NIAGARA MOHAWK POWER CORPORATION
OPERATOR JOB PERFORMANCE MEASURE

Nine Mile Point 2**Category "A" - Examination Outline Cross Reference**

Operating Test Number	Cat "A" Test: 1
Examination Level	SRO
Administrative Topic	A.1
Subject Description:	Shift Turnover
Question Number:	1

Question:	
Using the attached Survey 68 for Turbine Building 277' Condensate Demin Valve Aisle, identify the radiological posting(s) required at the entrance to the area, if any.	
SAT	UNSAT

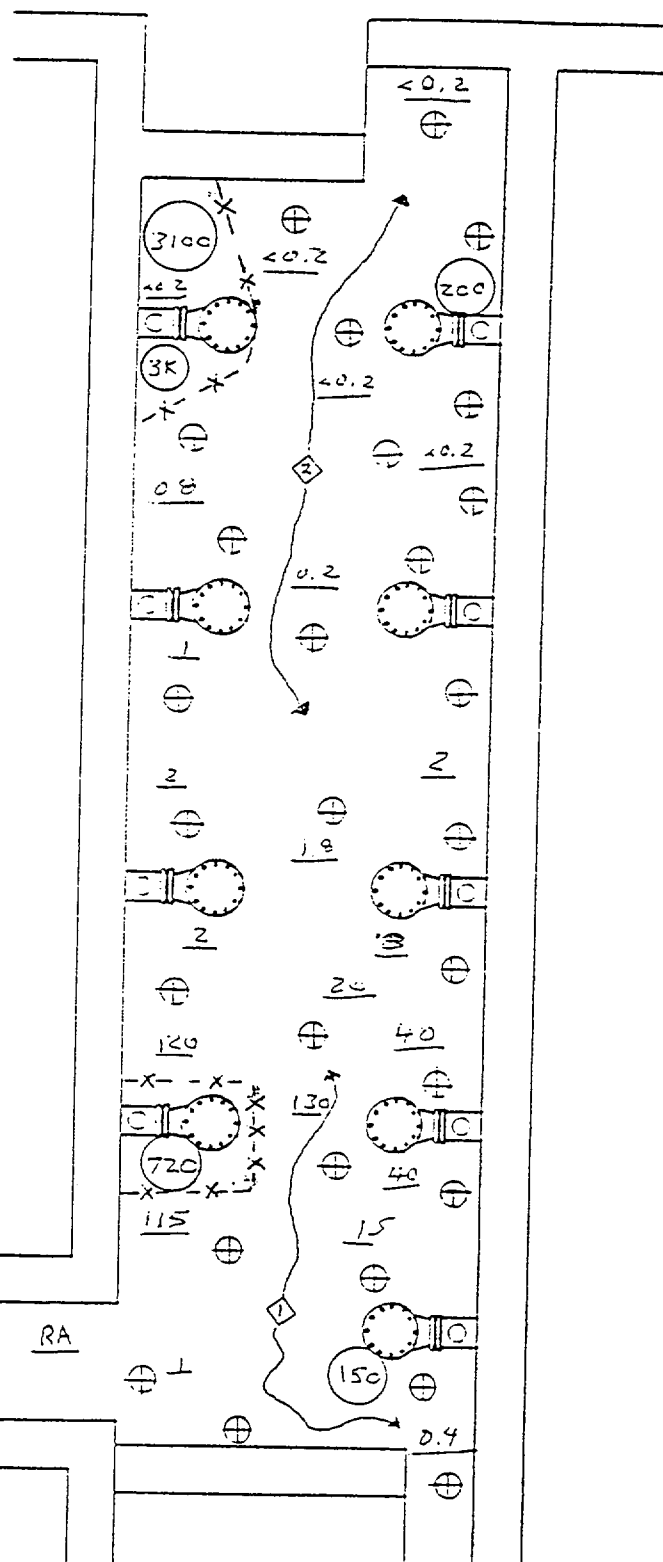
Comments:
NRC Comment: Add "if any". Change the word "hazards".
NMP2 Response: Added "if any". Changed "hazards" to posting(s) required at the entrance to the area.
